HANNAH RIDGE AT FEATHERGRASS FILING NO. 5

CONSTRUCTION PLANS

HANNAH RIDGE AT FEATHERGRASS FILING NO. 5, 6 & 7 OVERLOT GRADING AND EROSION CONTROL PLAN			
DESIGNED BY	KRC	SCALE	DATE 10/12/18
DRAWN BY	KC	(H) 1" = 50'	SHEET 3 OF 11
CHECKED BY		(V) 1" = NA	JOB NO. 1116.05

HANNAH RIDGE AT FEATHERGRASS FIL. 5			
CONSTRUCTION DRAWINGS			
DETENTION FACILITY NO. 1			
ROCK CHUTE / FOREBAY DETAILS			
DESIGNED BY	MAW	SCALE	DATE 10/12/18
DRAWN BY	MAW	(H) 1" = 5'	SHEET 11 OF 11
CHECKED BY	(V) 1" = N/A	JOB NO.	1116.05

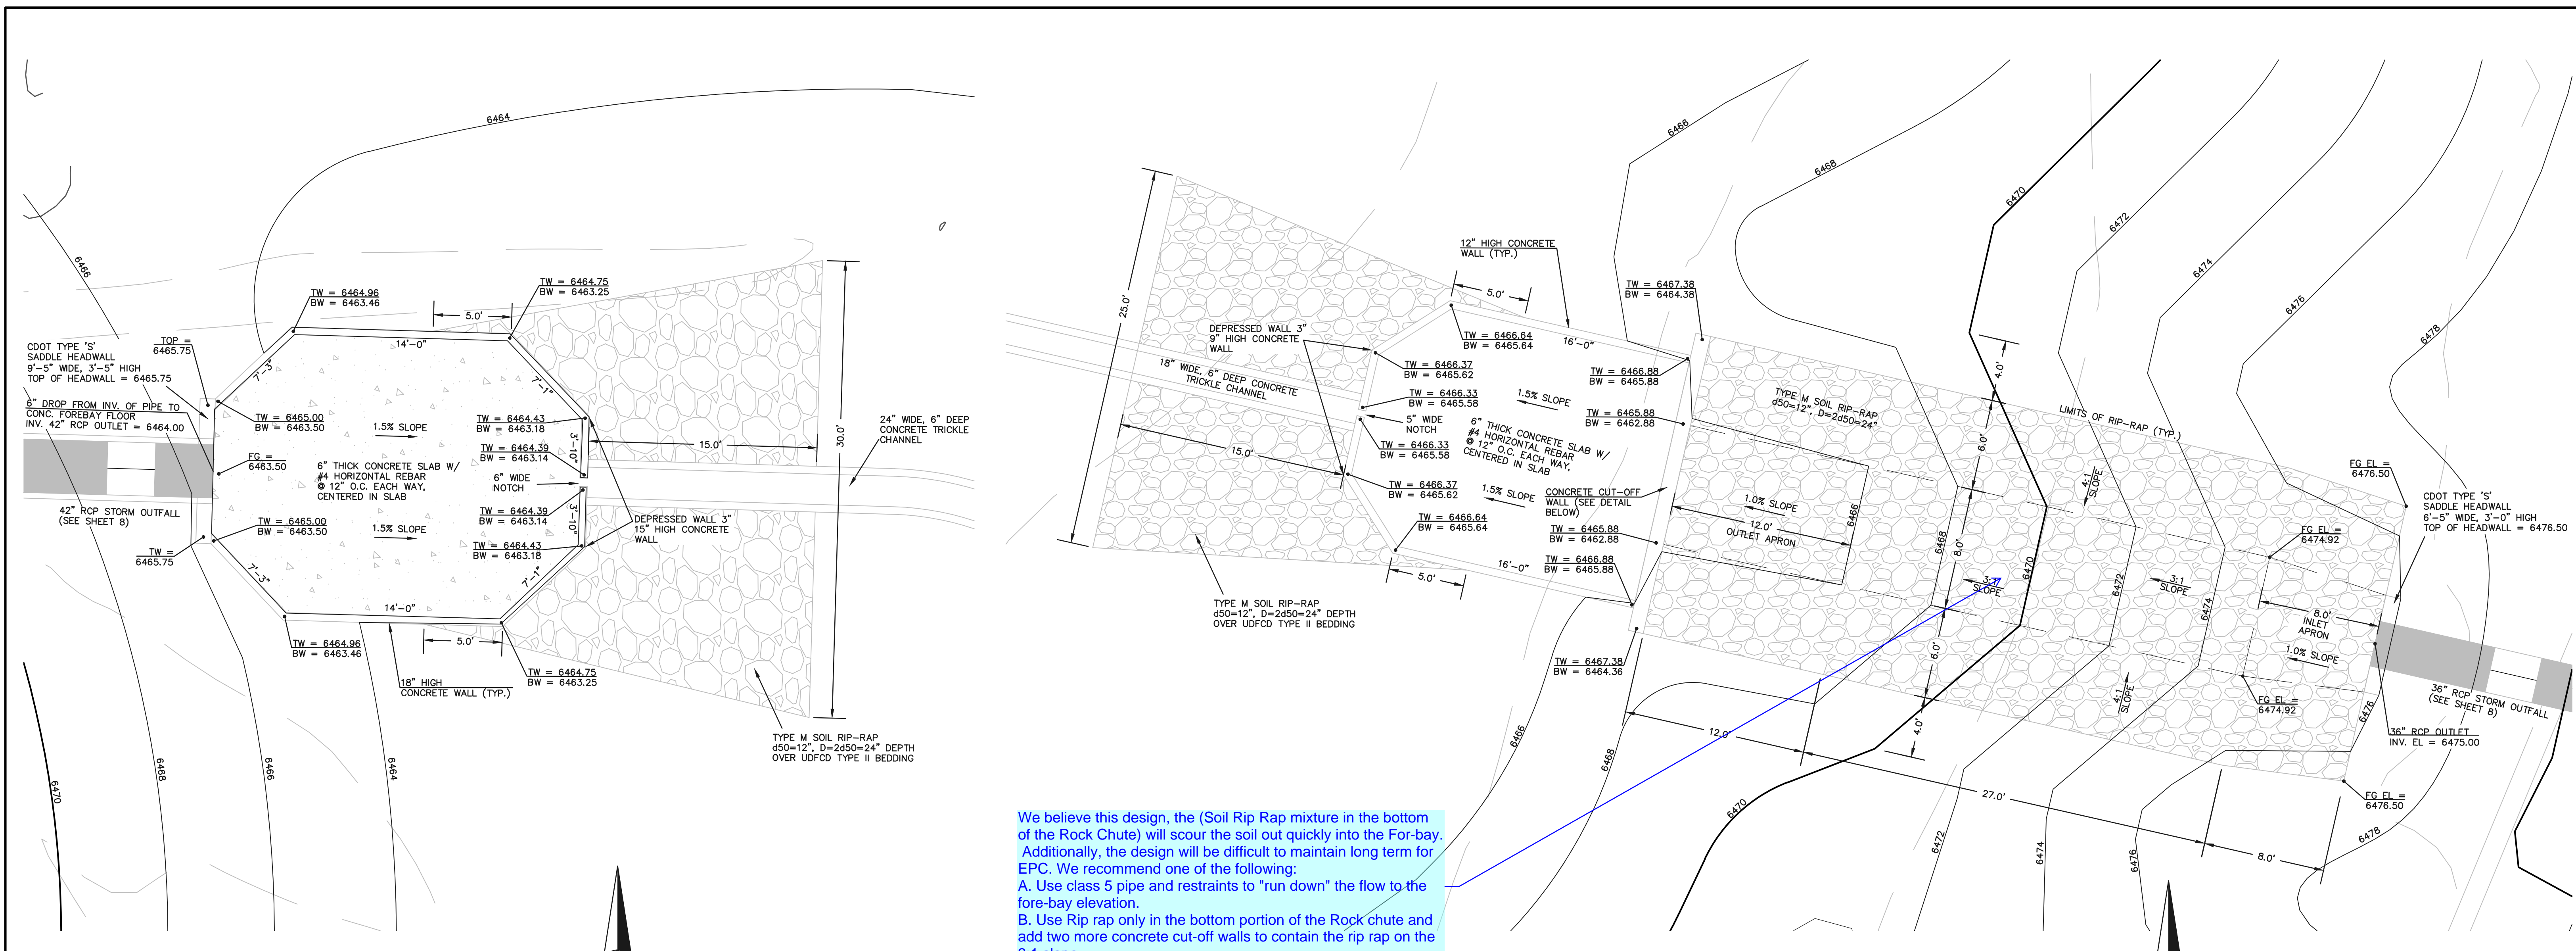
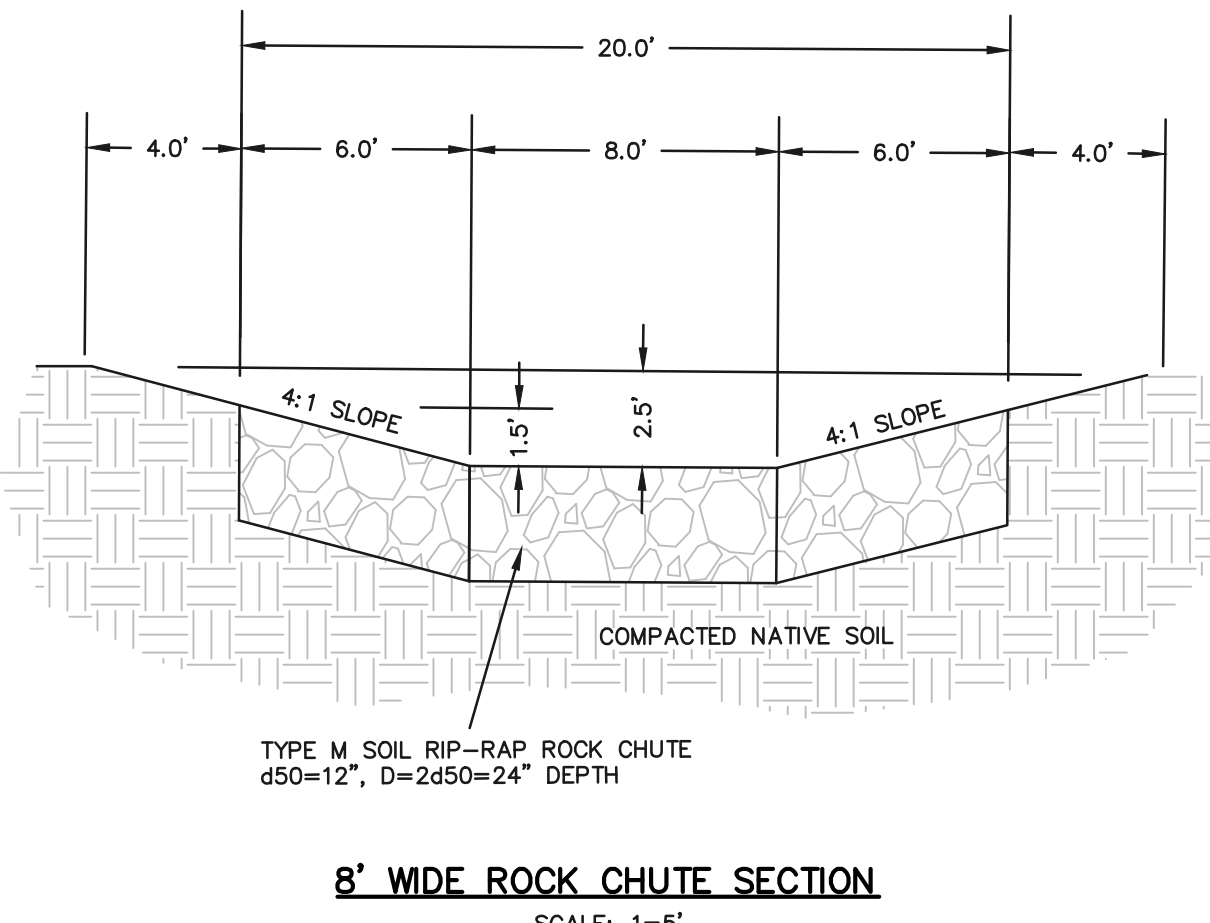
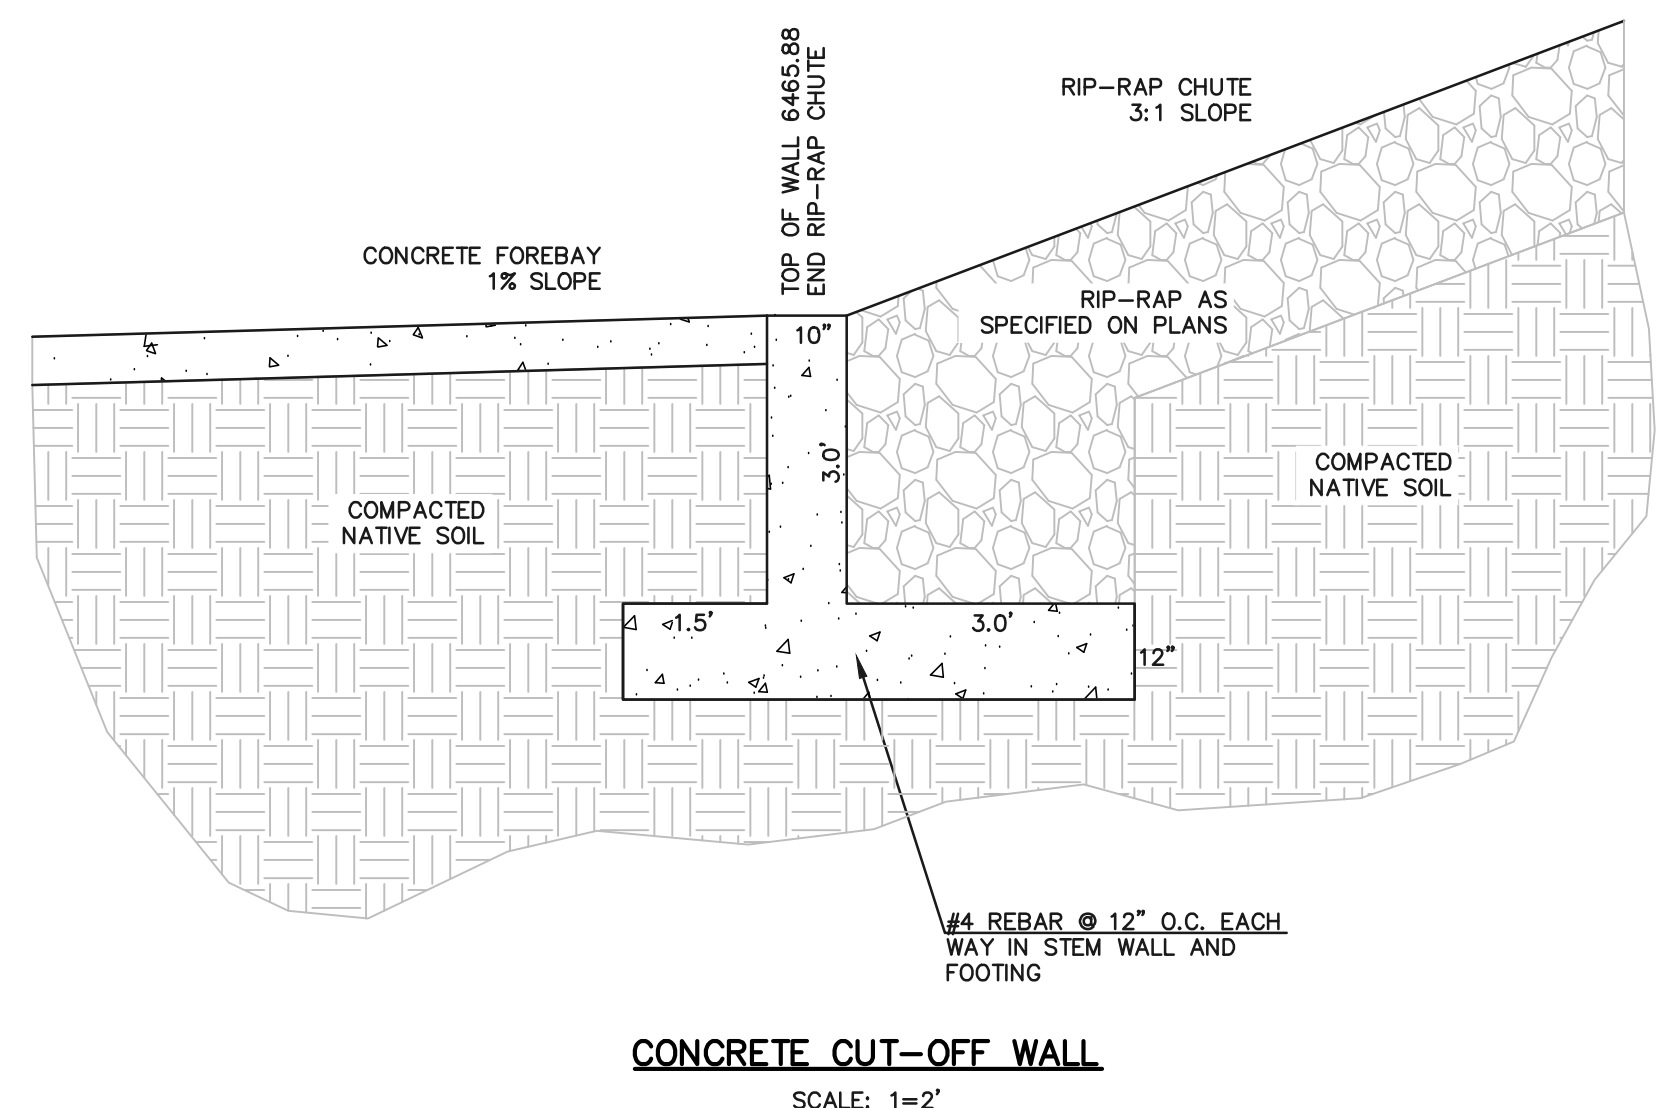
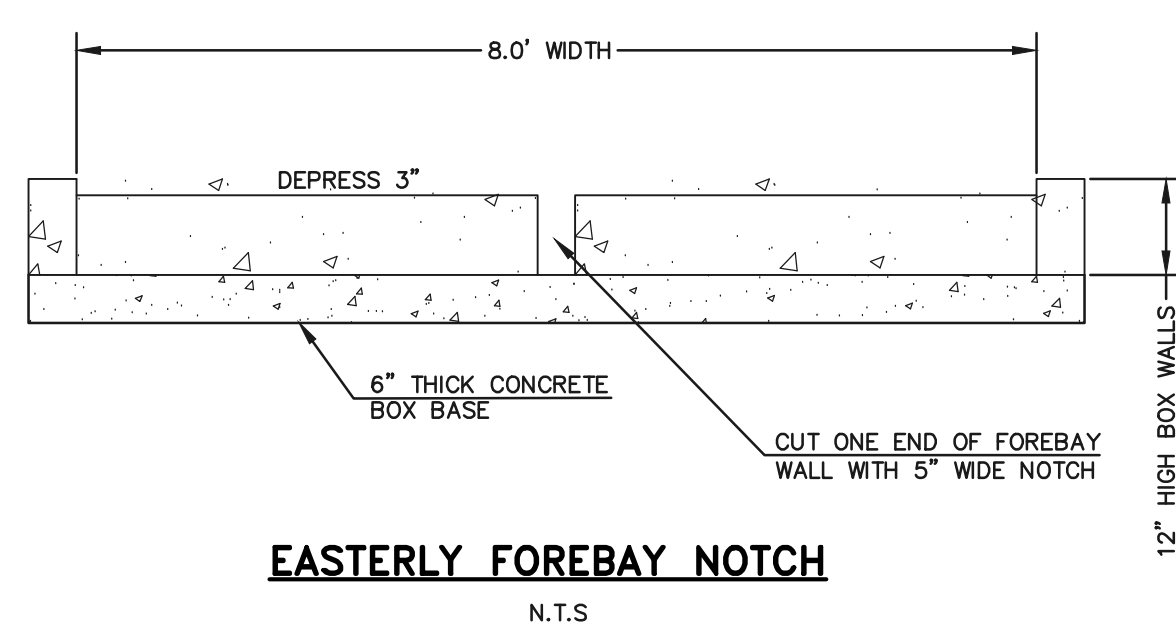
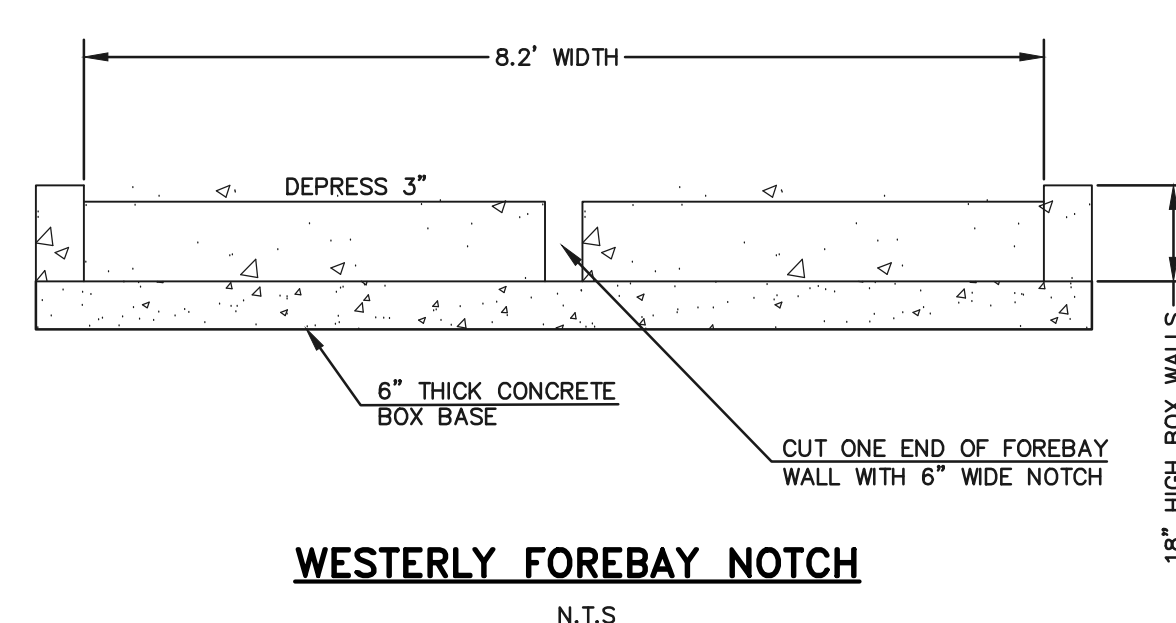
We believe this design, the (Soil Rip Rap mixture in the bottom of the Rock Chute) will scour the soil out quickly into the For-bay. Additionally, the design will be difficult to maintain long term for EPC. We recommend one of the following:
 A. Use class 5 pipe and restraints to "run down" the flow to the fore-bay elevation.
 B. Use Rip rap only in the bottom portion of the Rock chute and add two more concrete cut-off walls to contain the rip rap on the 3:1 slope.
